SAN JOAQUIN VALLEY AIR DISTRICT HEARING BOARD

S.R.H.B. Case No.: S-26-11A

**TRIAL BRIEF FOR HEARING AND
APPEAL OF APPROVAL OF
AUTHORITY TO CONSTRUCT
PERMIT FOR KERN ENERGY
REFINERY PROJECT NO. S-1251187**

Figure 2. Annotated Hydrogen Energy Production Flow Diagram.

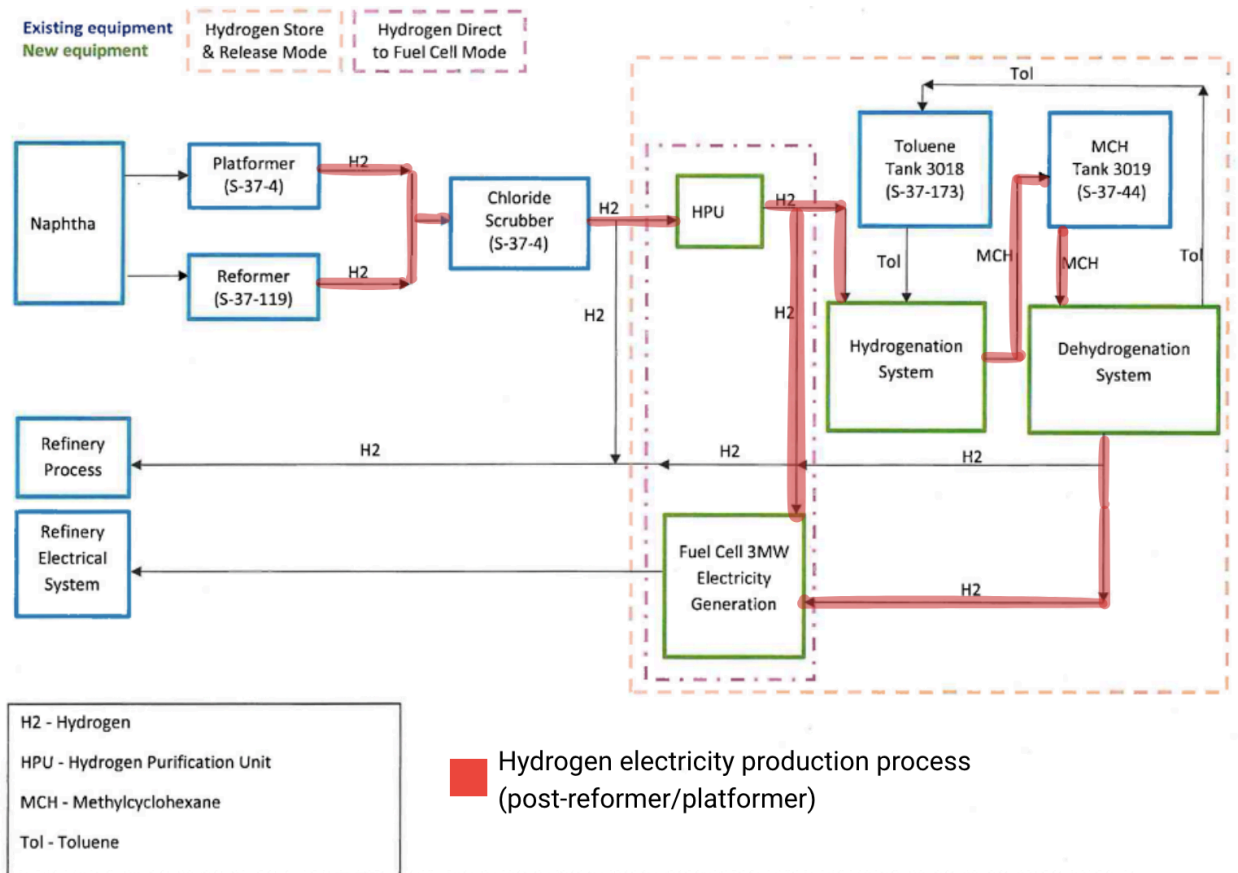
25
26 Use of hydrogen in the refining process is nothing new, but the Project proposes a major
27 shift in how hydrogen moves through different equipment to produce an entirely new product
28

While we cannot be entirely confident this is a complete picture of the hydrogen recovery and energy production permit unit, the following is a non-comprehensive list of emission units and conveyances that must be considered by the District as part of the permit unit, per District guidance:

Figure 3. Map of Hydrogen Recovery Project, *Exhibit D*.

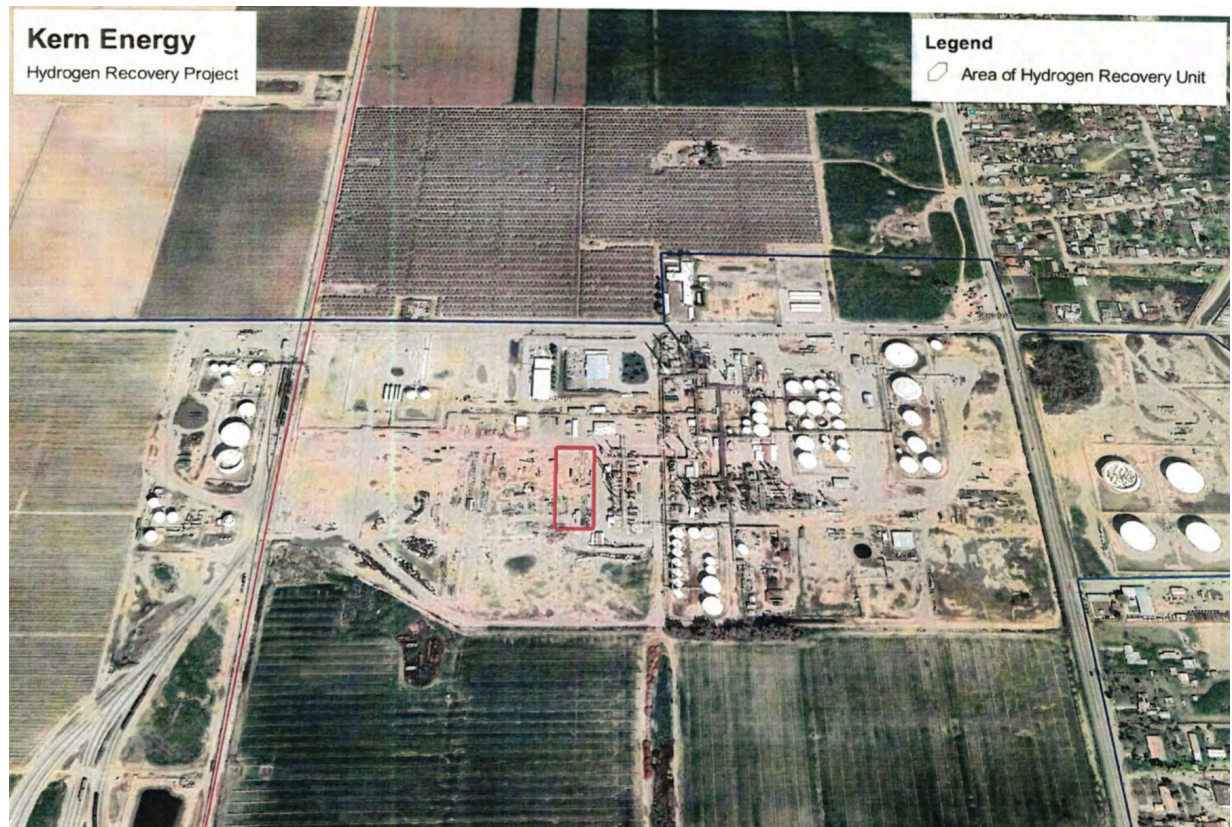
12 Lastly, there may even be further modifications that Petitioners are not aware of, as the
13 District does not provide a sufficiently detailed schematic. The schematic and Project description
14 provided in the Engineer’s Report exclude relevant details regarding the location and connections
15 to the platformer, chloride scrubber, reformer, and organic liquid storage tanks. Kern Energy
16 provided a map of the fuel cells and hydrogenation equipment in the Project Plot Plan submitted
17 to the County (**Figure 3**) that demonstrates that substantial piping will be required to connect the
18 fuel cells to other parts of the permit unit, which must be reflected in the permit determination.
19 Not only did Kern Energy fail to provide this information to the District, but the District also
20 failed to request it. This information is necessary to understand the operational changes to
21 existing equipment. Changes could include the reversal of transportation pathways, a change in

22 the substance transported through existing piping, or changes in connections.
23
24
25
26
27

Figure 4. APR 1025 Permit Determination Diagram.

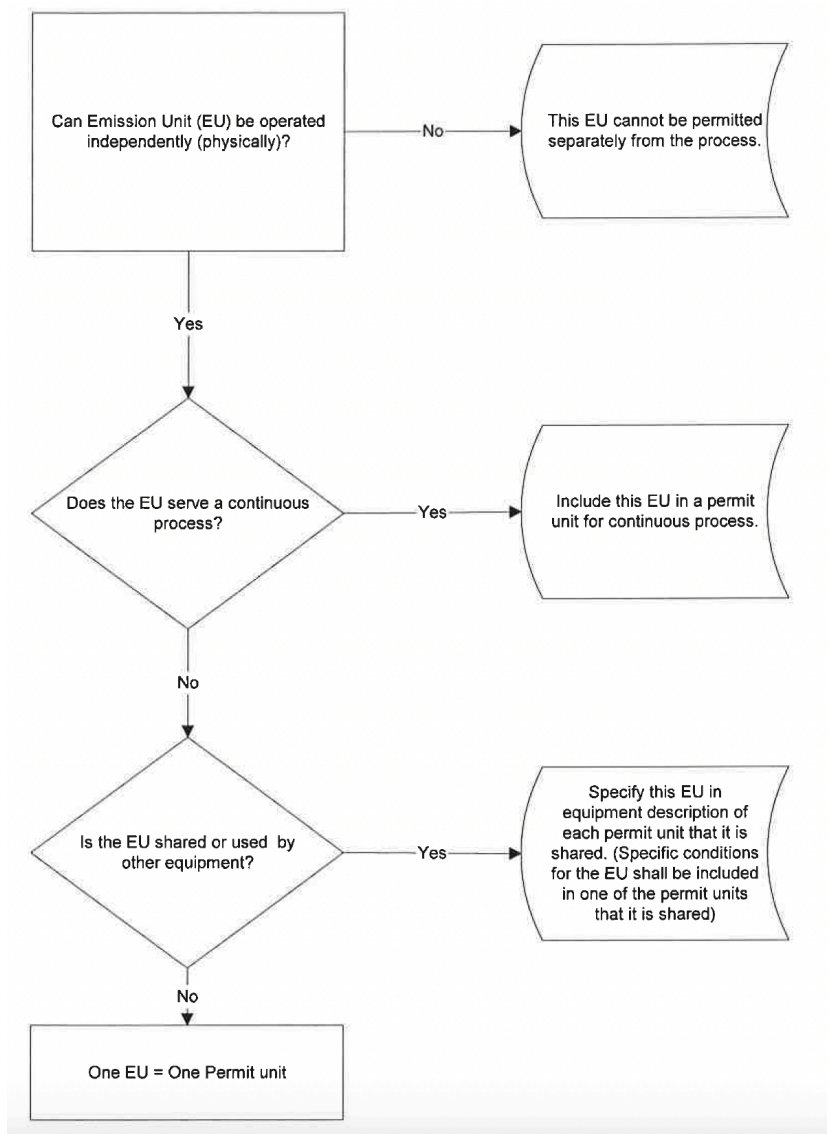
The District's exclusion of these five emission units is also inconsistent with the District's own permit determination diagram (**Figure 4**). Application of the diagram to each emission unit unequivocally results in the determination that they should be part of the same permit unit:

- The Naphtha Reformer can be operated independently and serves a continuous process. Thus, it must be included in the permit unit for the continuous process.
- The Platformer can be operated independently and serves a continuous process. Thus, it must be included in the permit unit for the continuous process.
- The Chloride Scrubber cannot be operated independently. Thus, it cannot be permitted separately.
- The Toluene Tank cannot be operated independently. Thus, it cannot be permitted separately.

- The MCH Tank cannot be operated independently Thus, it cannot be permitted separately.
